Rezoning Transportation Analysis

Petition Number: 2018-142

General Location Identifier: 21101102, 21101106, 21101108

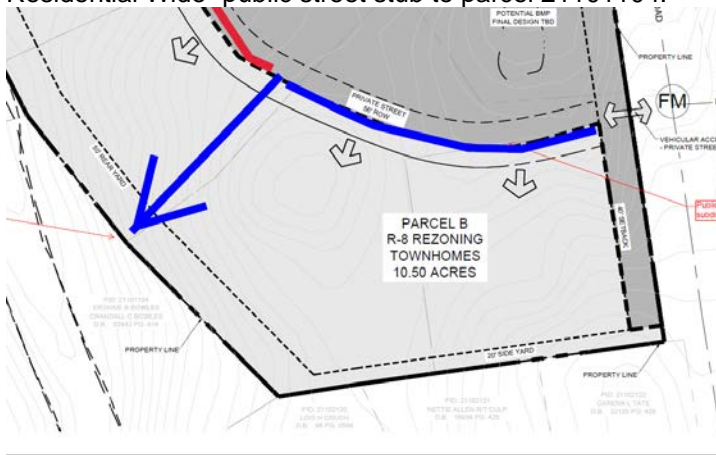
4. The petitioner should revise the site plan and conditional note(s) to construct a "Local Residential Wide" street from existing Hamilton Mill Road to the norther access point.

- a. The site plan and note(s) should commit to constructing and designating the southern portion as a public street (blue).
 - b. The site plan and conditional notes should commit to designating the northern portion as a private street with an easement (red).
